Transportation & Development – PZ Memo No. 13-048

SUBJECT: PDP13-0002 CHANDLER MIDWAY CORPORATE CENTER

Request: Preliminary Development Plan (PDP) approval to allow freestanding multi-tenant monument signs for an existing development

Sign A

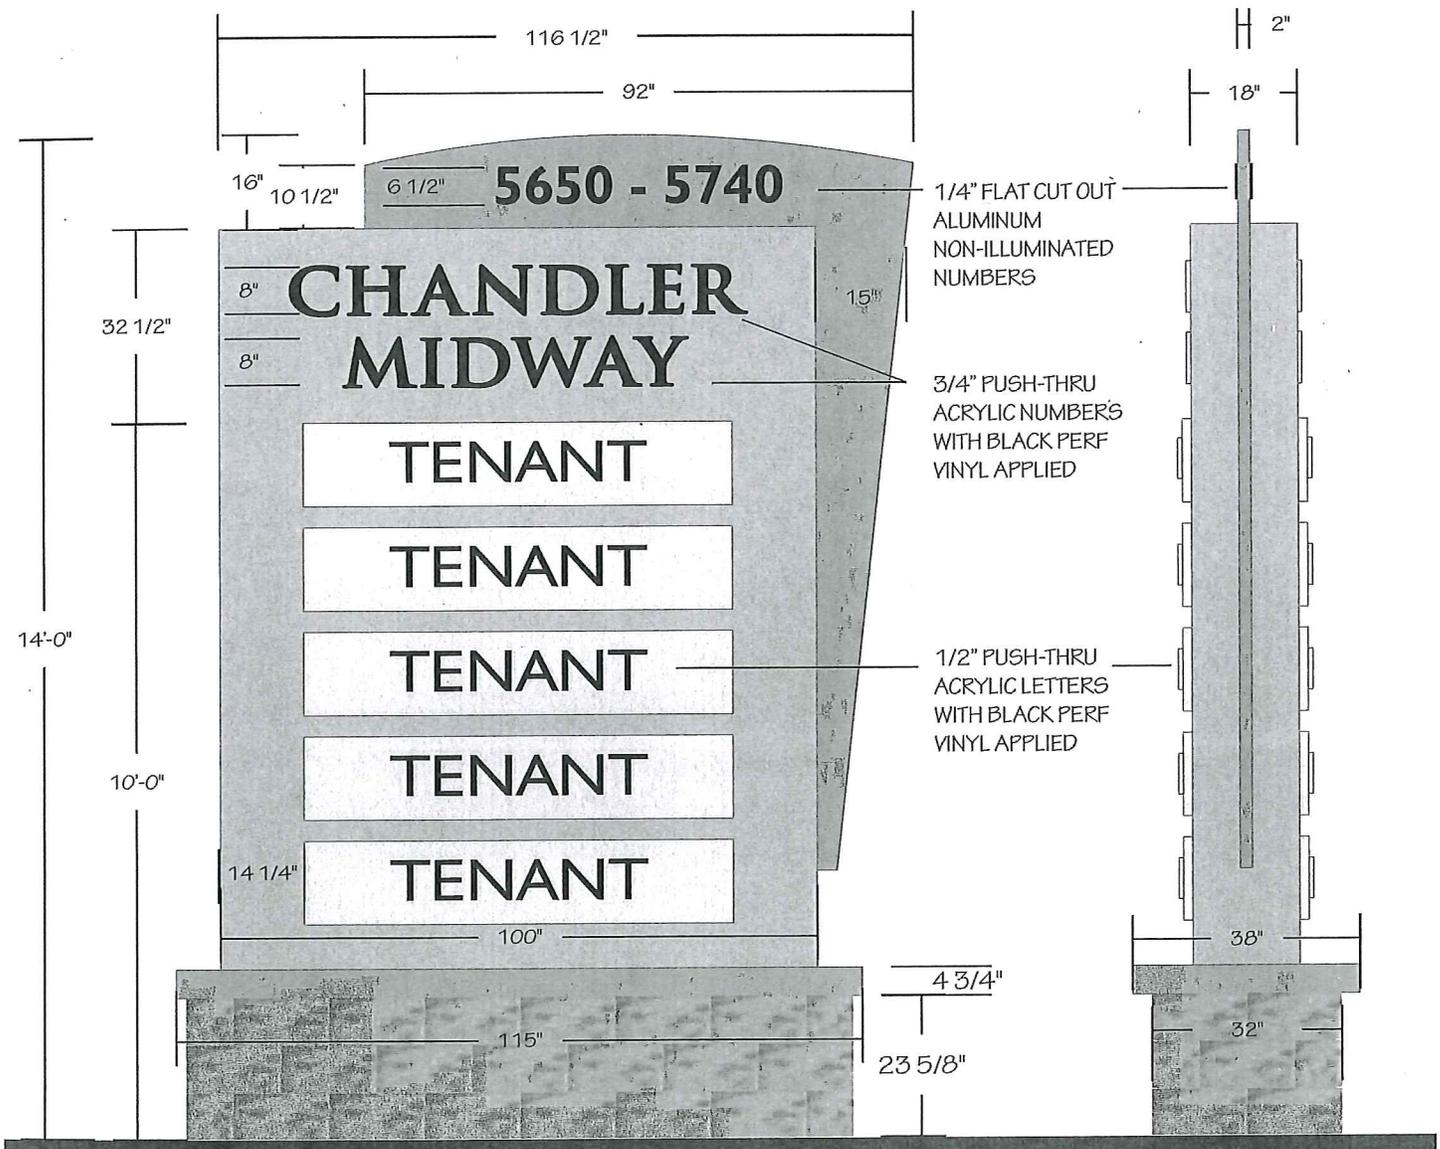
The proposed multi-tenant monument signs include one along Chandler Boulevard (Sign A/a) and one along Gila Springs Boulevard (Sign B/b). Sign A has an overall height of 14 feet with 5 tenant panels. Sign B has an overall height of 10 feet with 5 tenant panels. The signs are located in proximity to the main entrances to Chandler Midway Corporate Center.

Planning Staff finds the proposed two freestanding monument sign's height and number of tenant panels appropriate for this development. The development's largest tenant buildings are located approximately 500 feet north of Chandler Boulevard with limited visibility. The monument signs are architecturally designed to match the office development incorporating a geometric element, which enhances the sign's quality. The proposed signage is consistent with office developments of this size with height and number of panels.

Sign a

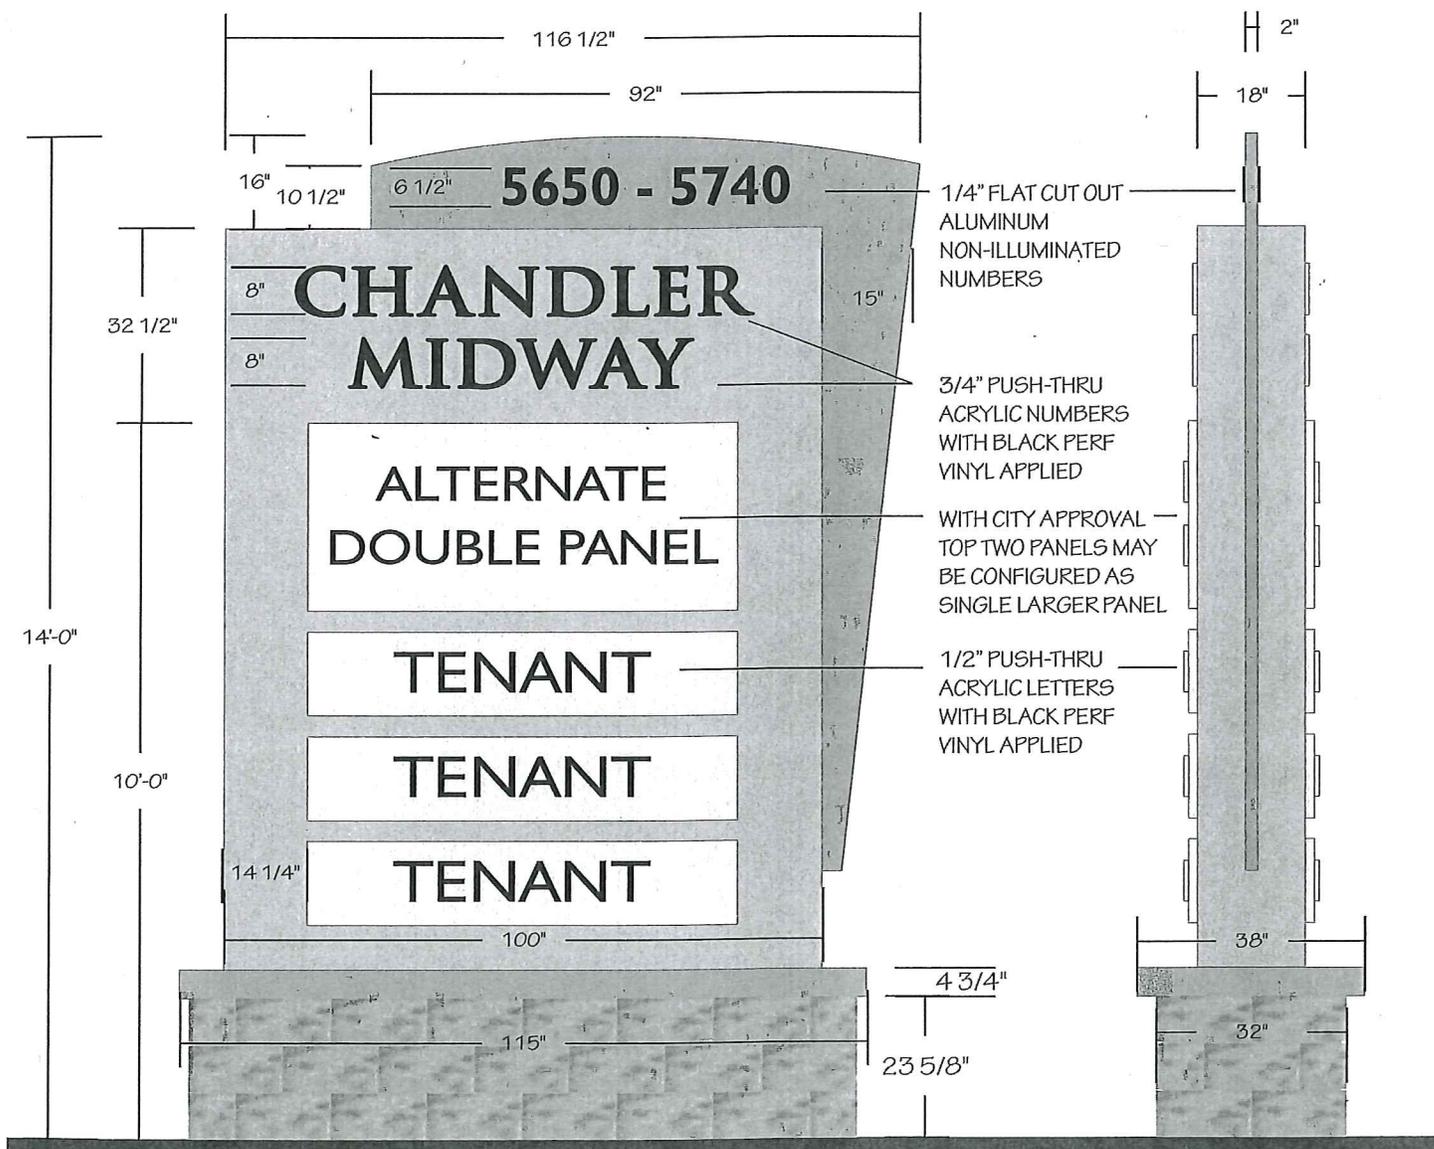
The signs incorporate building materials, colors, and elements from the development's office buildings. The sign is constructed with an aluminum cabinet and internal illumination and a split face block base. The center identification name and tenant panels are routed-out push-thru acrylic letters. Lettering projects from the sign's face to provide dimension from side elevations. The acrylic lettering is a perforated vinyl which appears black during the day and white at night when illuminated. There are a maximum of 5 tenant panels of equal size and height. There is an option to combine only the top two panels creating a total of 4 tenant panels. The Development Booklet includes exhibits representing both options.
